NACIMIENTO WATER PROJECT
 ADDENDUM NO. 03
 for
 PIPELINE SOUTH
 CONTRACT NO. 300187.08-05
 SPECIFICATION No. 05

ADDENDUM

DATE: July 24, 2007
PROJECT: Pipeline South
ADDENDUM NO.: 3
BID OPENING: August 2, 2007

UNIT T11 - SAN LUIS OBISPO TURNOUT
ELECTRICAL
ONE-LINE DIAGRAM

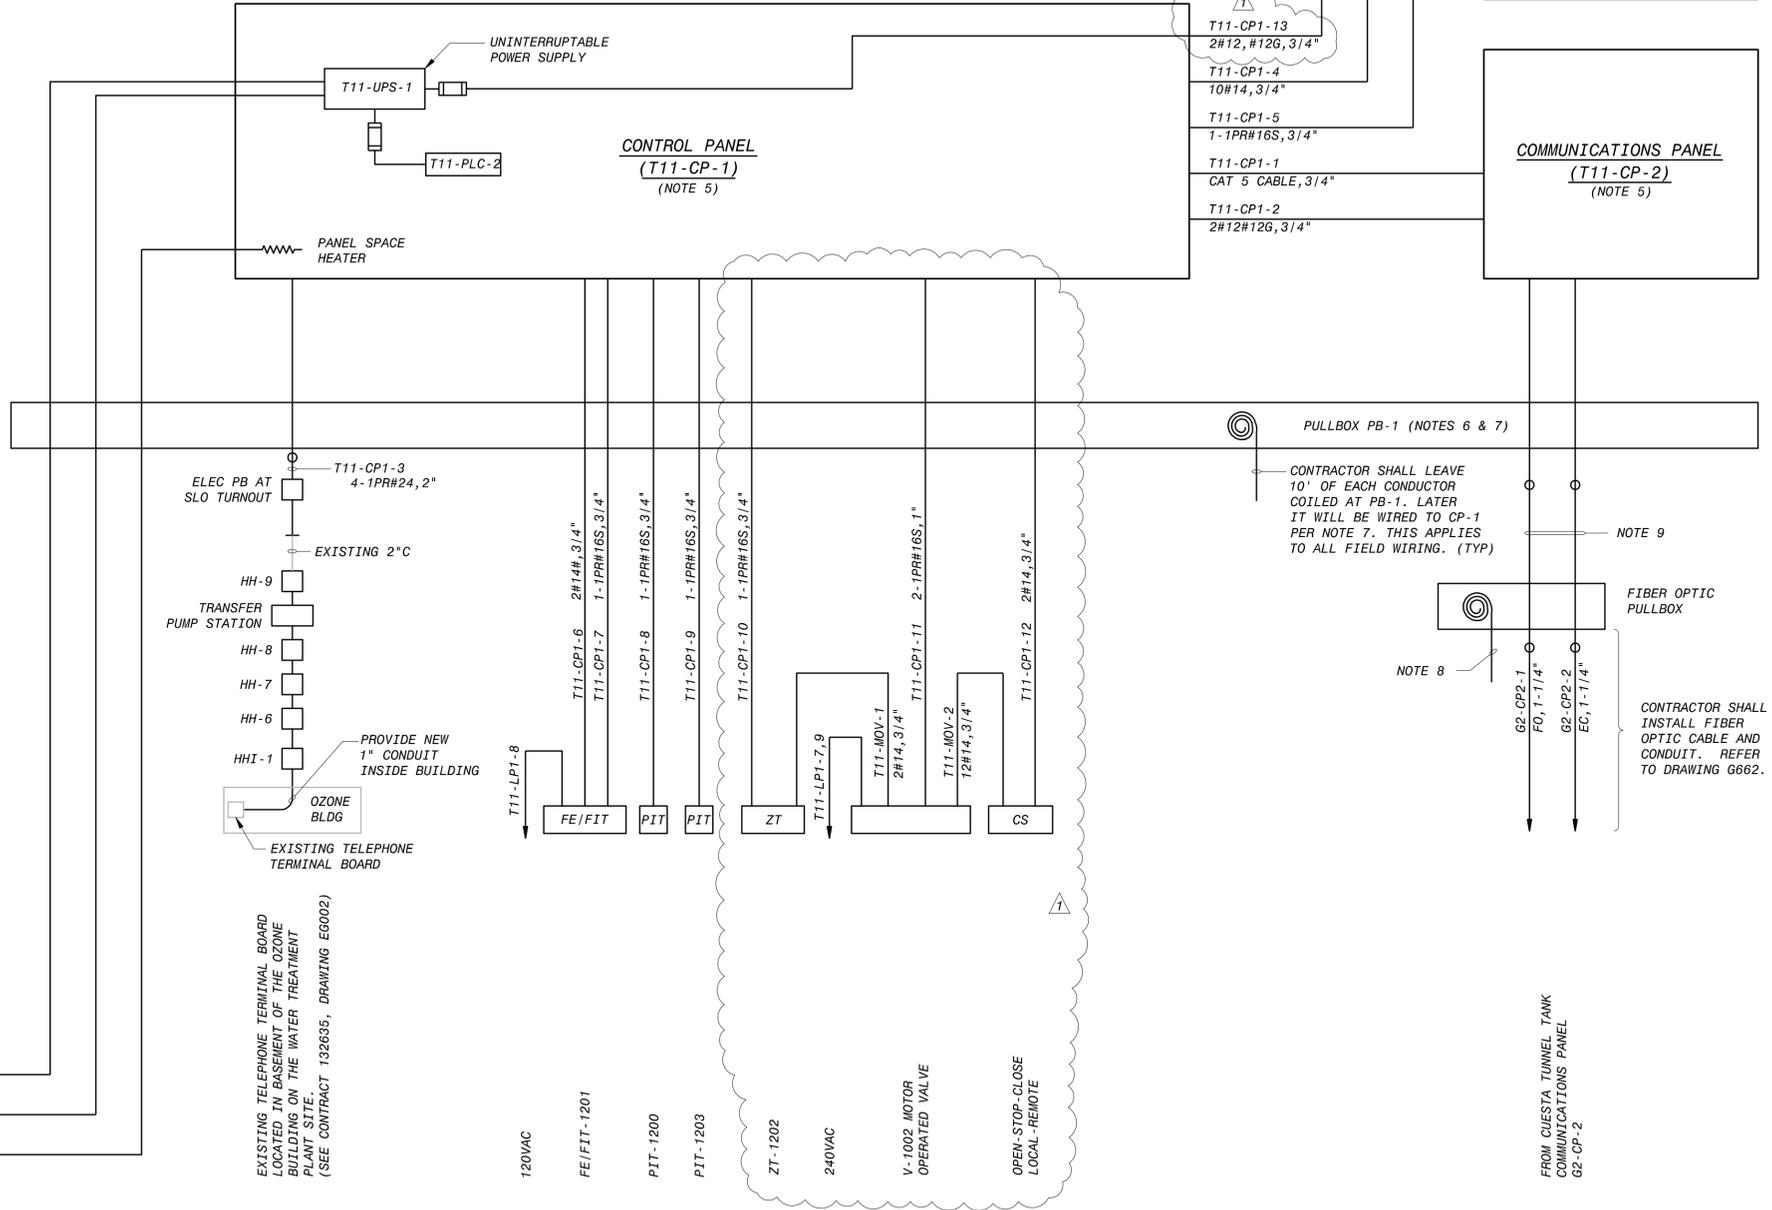
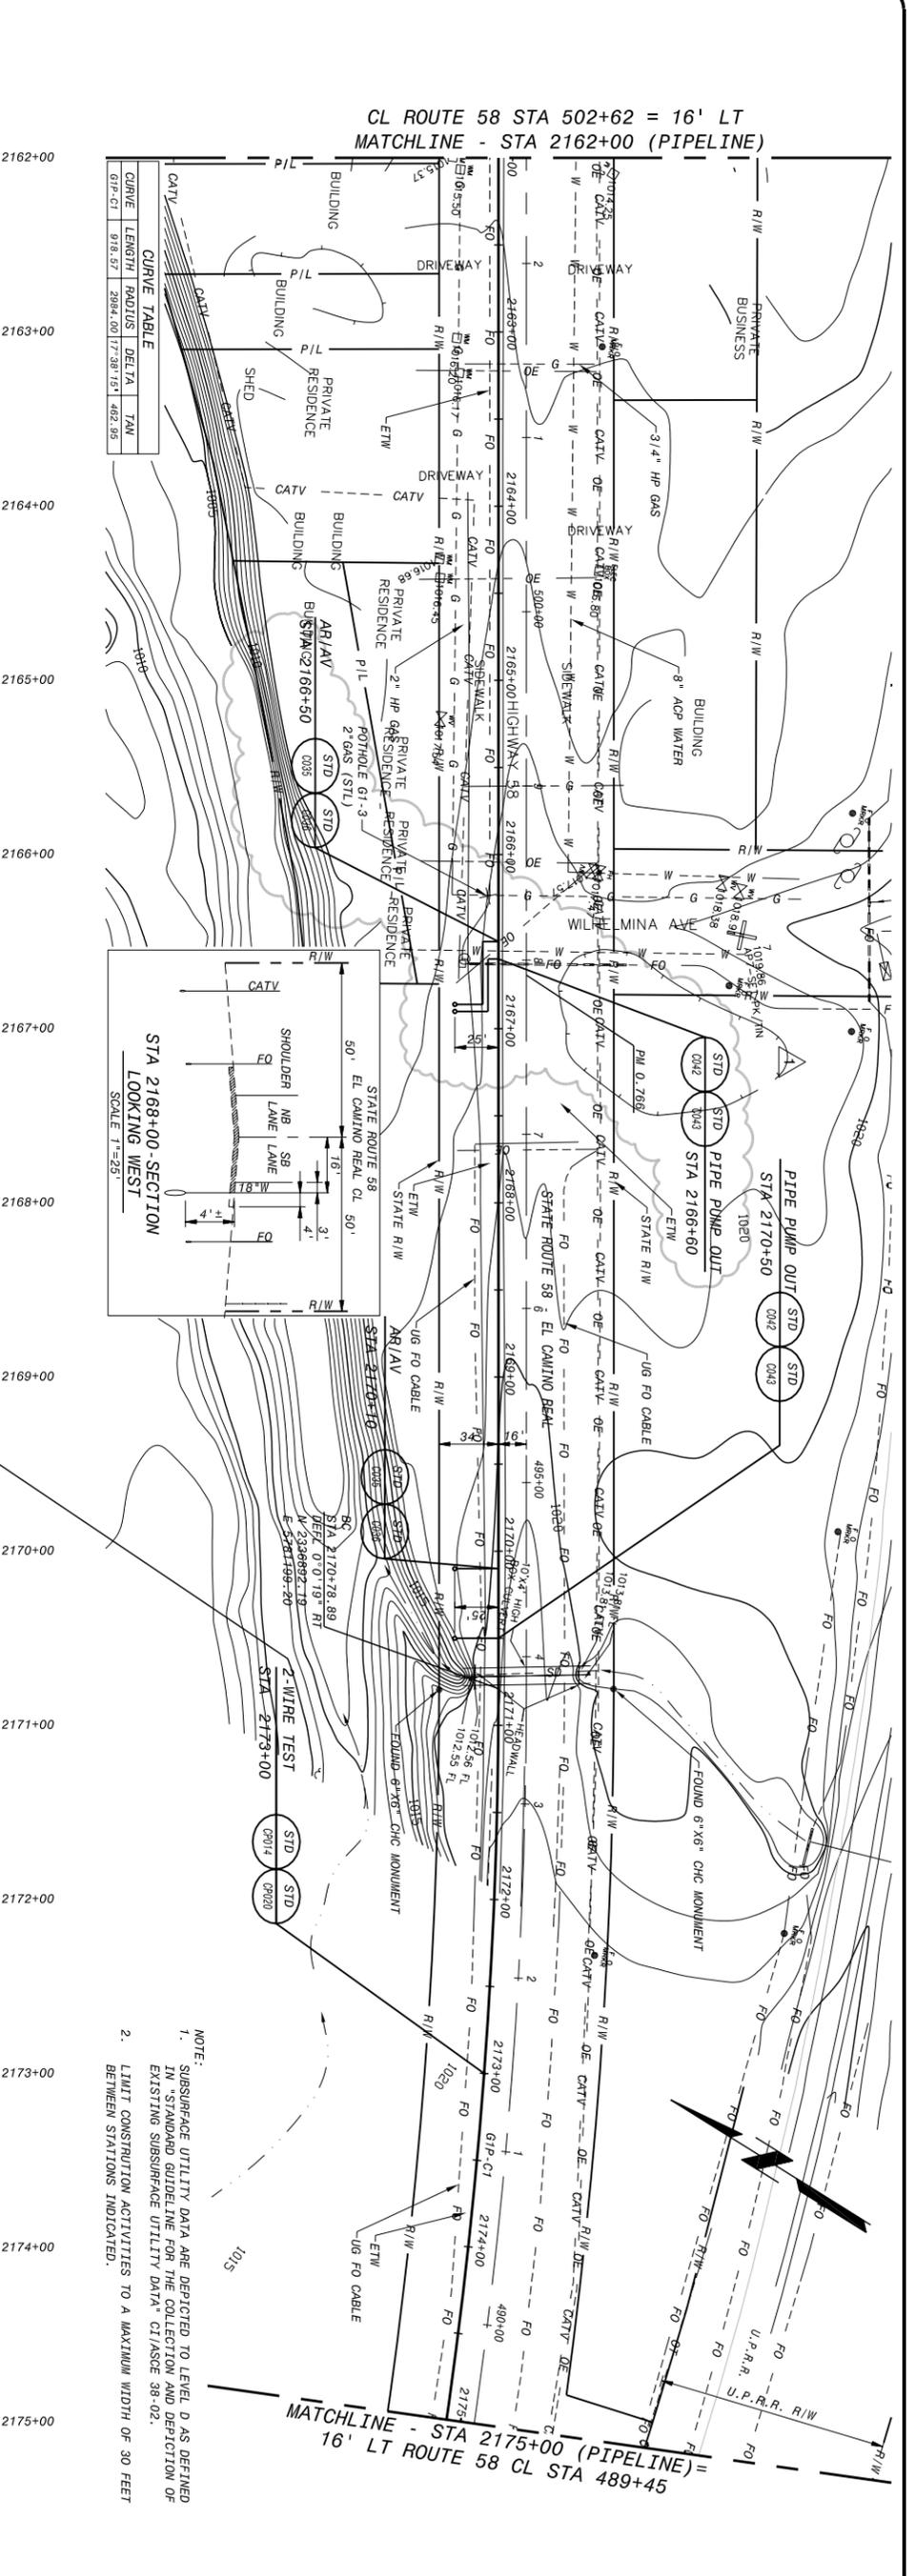
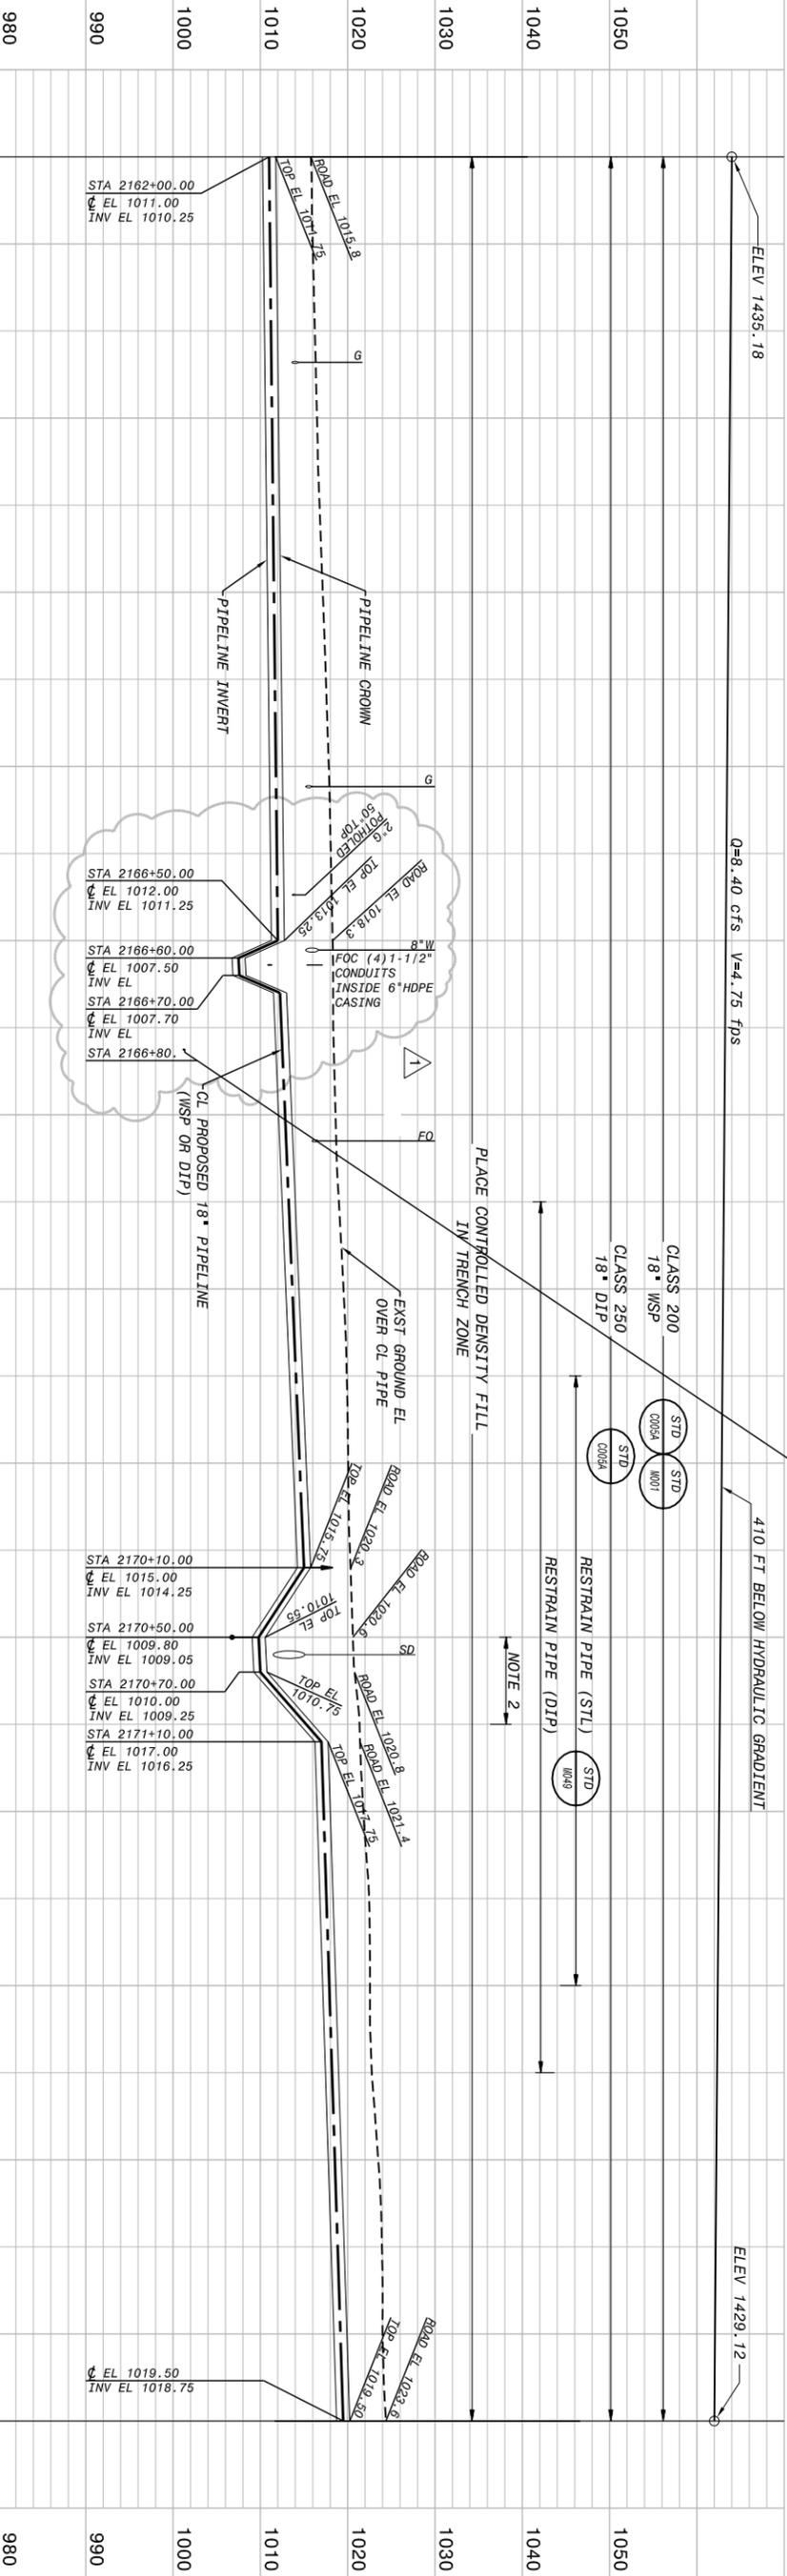
9. Drawing G1P-C280, Sheet 74 of 155, added fiber optic conduits and modified pipeline profile as shown in Drawing G1P-C280 Revision 1, attached.
10. Drawing T11-E601, Sheet 146 of 155, replace the original bid set drawing with T11-E601 Revision 1, attached.
11. Drawing G002, Sheet 2 of 155; make the following revisions:
 - Add the following to the end of Note 29:

Drawing No.
 GP-C252

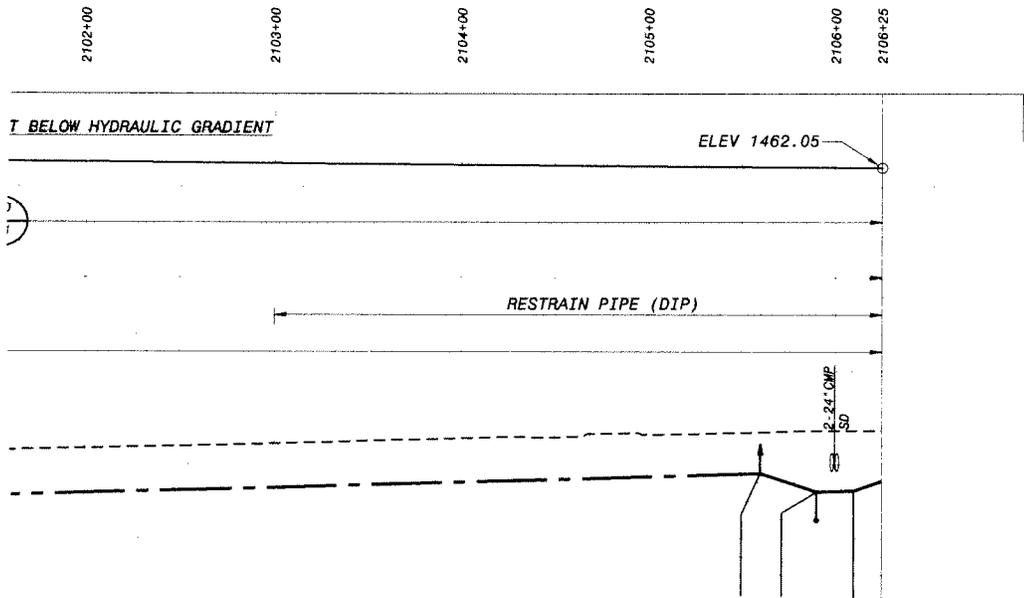
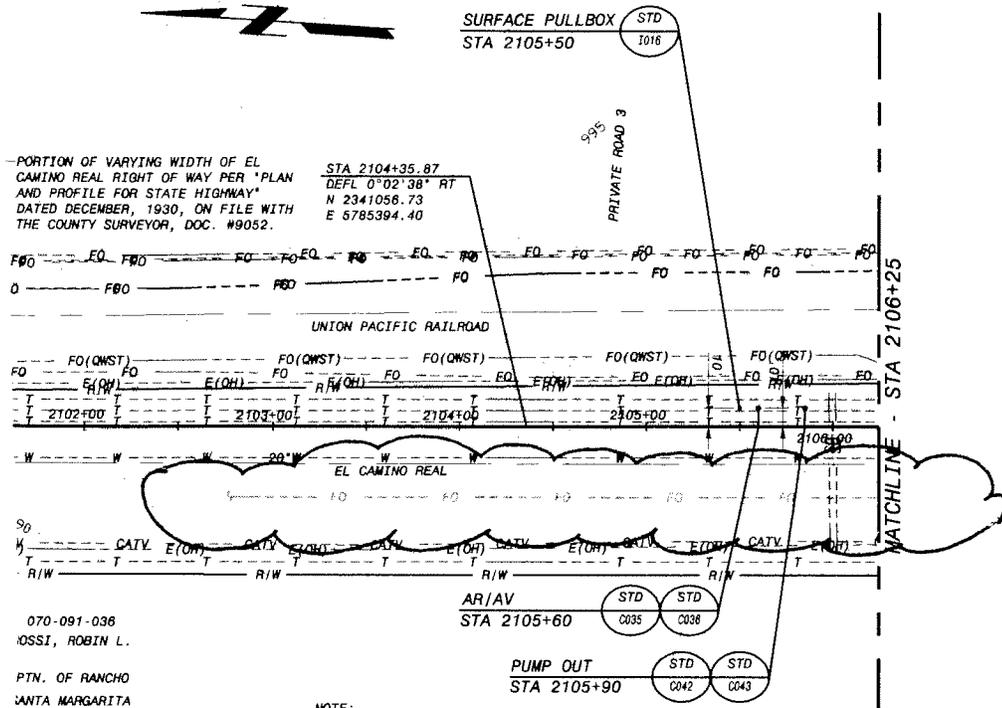
2. Drawing T11-I601, add a sample port to the turnout pipeline downstream of V-1004.
3. Drawing GP-C252, Sheet 18 of 155, added fiber optic conduits at approx. Sta 1831+80 as shown on attached Sketch 300187.08.05-SK12.

Added Fiber Optic Conduits

Sheet No. 62 of 155	Drawing No. GP-C274	Sketch No. 300187.08.05-SK13
------------------------	------------------------	---------------------------------

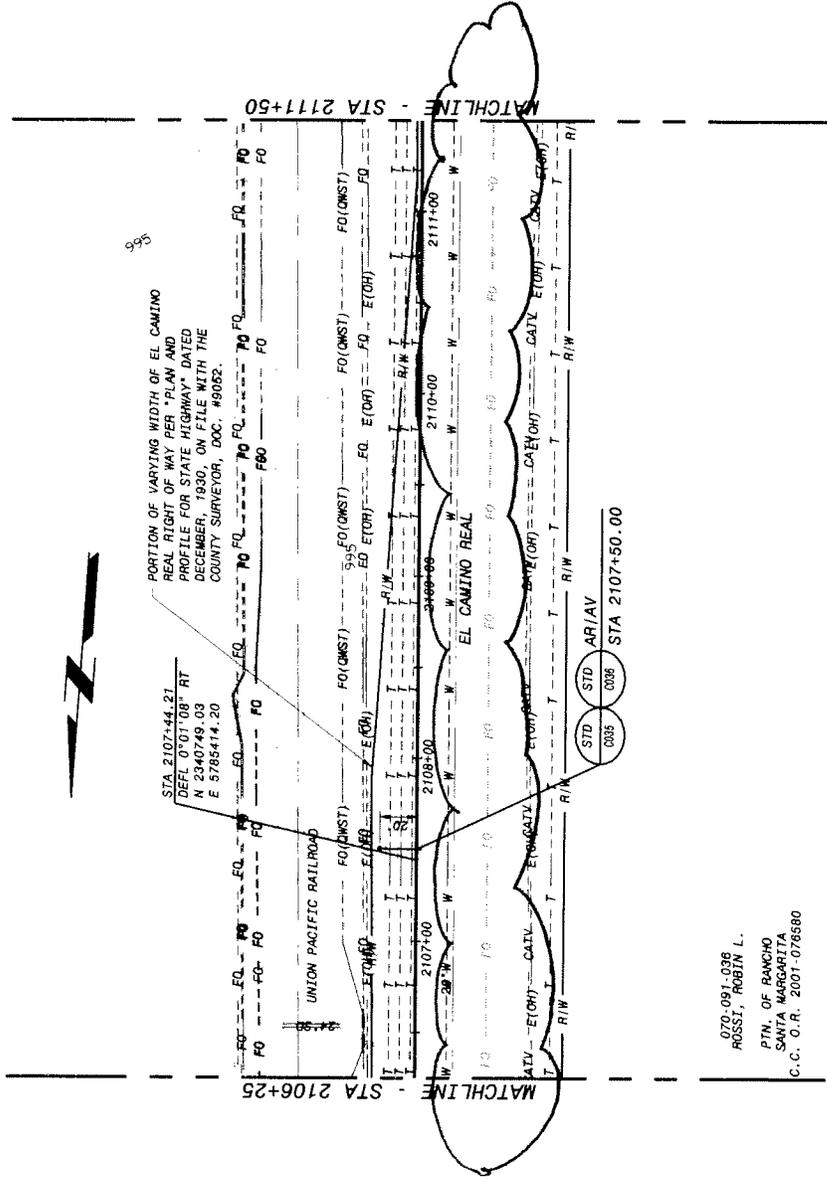
4. Drawing GP-C274, Sheet 62 of 155, added fiber optic conduit as shown on attached Sketch 300187.08.05-SK13.
5. Drawing GP-C275, Sheet 64 of 155, added (4) 1-1/2” fiber optic conduits as shown on attached Sketches 300187.08.05-SK14, -SK15, and –SK16.

Added Fiber Optic Conduit

Drawing No.
GP-C278

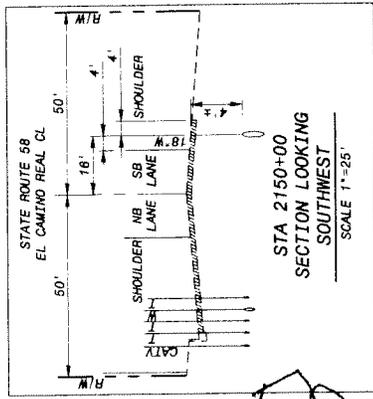
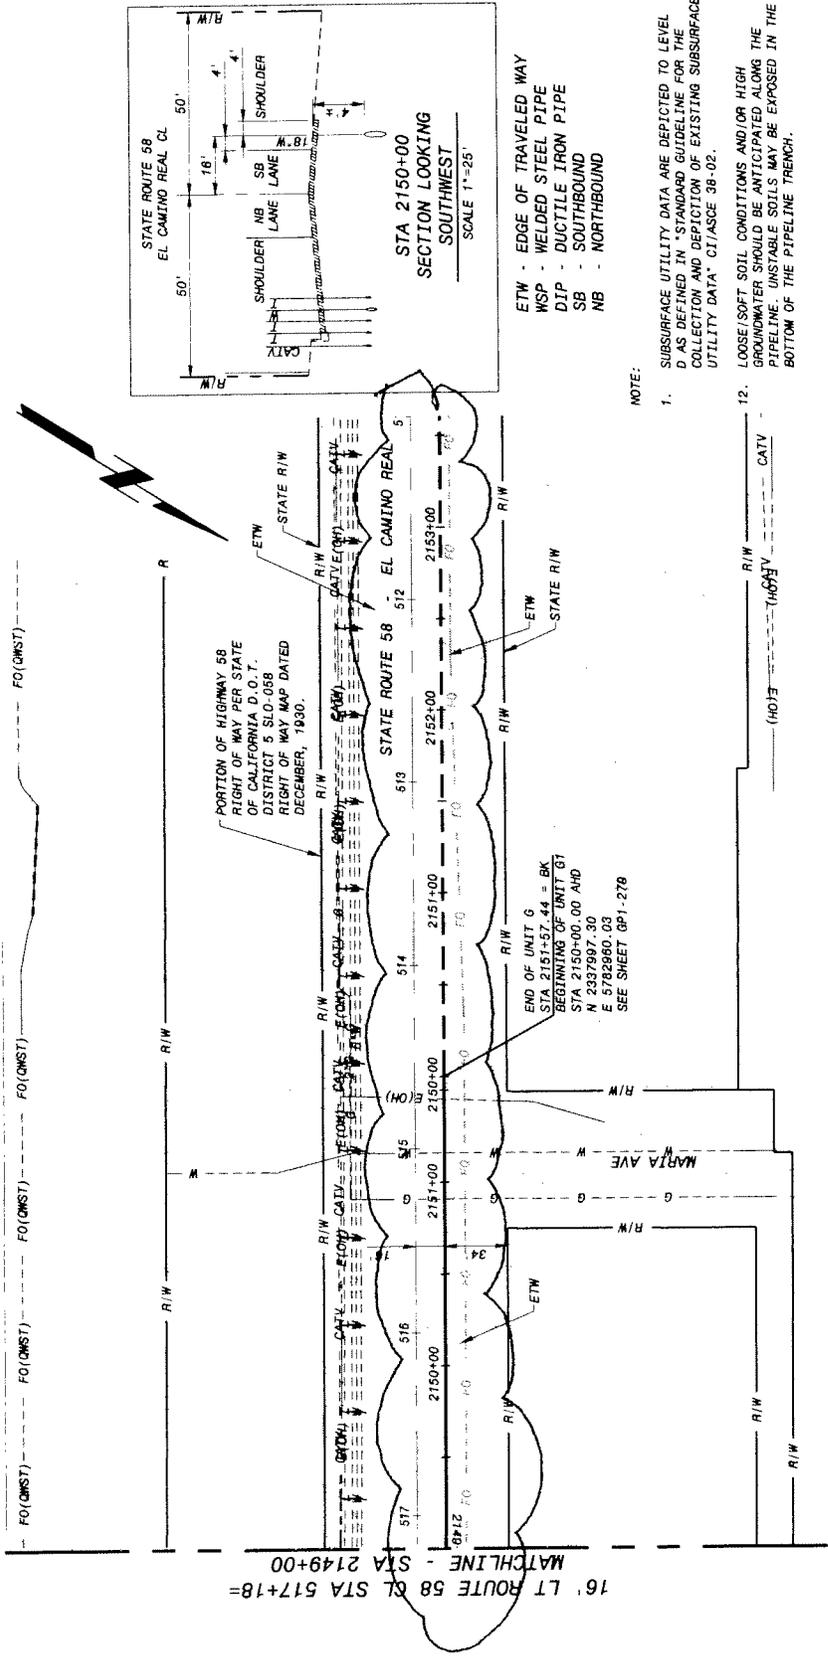
6. Drawing GP-C278, Sheet 70 of 155, added (4) 1-1/2” fiber optic conduits as shown on attached Sketches 300187.08.05-SK17 and –SK18.
7. Drawing GP-C278, Sheet 70 of 155, revise the fitting at Sta 2146+20.91 from an 18” elbow to an 18” tee with a blind flange installed on the branch that points northeast on El Camino Real.

Added Fiber Optic Conduits
